Montecillo Unit Eight Replat A

City Plan Commission — March 27, 2025 POSTPONEMENT REQUEST

CASE NUMBER/TYPE: SUSC25-00001 – Resubdivision Combination

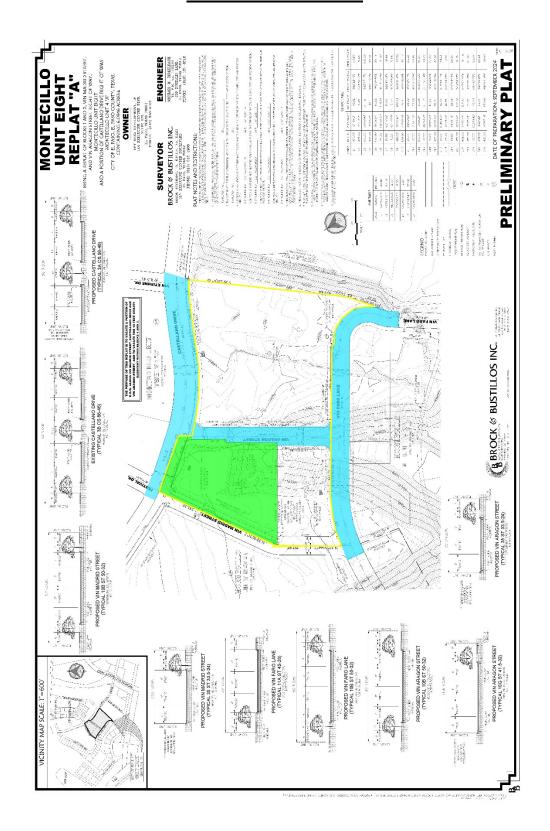
- 4. Vin Faro Lane includes two cross-sections with different proposed transition widths; however, these are not reflected on the plat. The plat currently indicates on a 50' ROW width.

- 8. Lot number on the preliminary plat are not clearly legible please ensure they are distinguishable.
- 9. Revise the preliminary plat showing the improvements

Check Preliminary Plat for incorrect dimensioning (representation of) of median (0'-10' of 66' R.O.W.

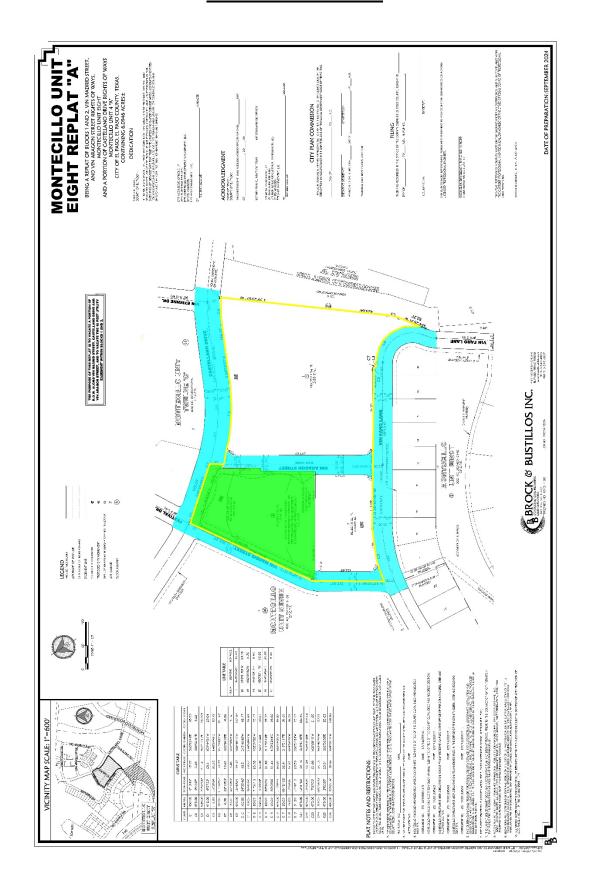
- 3. The proposed transition widths for Vin Madrid Street and Castellano Drive do not meet the requirements outlined in the Street Design Manuel (SDM) Section 4.11.6 Transitions of Right-of-Way Width. Per this section: Wherever the right-of-way width of a residential, local, collector or arterial street must transition to a greater or lesser width., **the transition shall not occur within an intersection** but within the street right-of-way so that the right-of-way shall be the same on both side of the street intersection. **The minimum taper length of the right-of-way transition taper shall be 100 feet**.

- 5. Please provide articles of incorporation authorizing Mr. Bogas to sign on behalf of the owner.
- 6. Label the park on the plats.
- 7. Provide a copy of the plat or instrument that dedicated the public easements and right-of-way, including the recording information.

Please note the existing line in Lot 1, Block 1 and also note 10' wide easement.
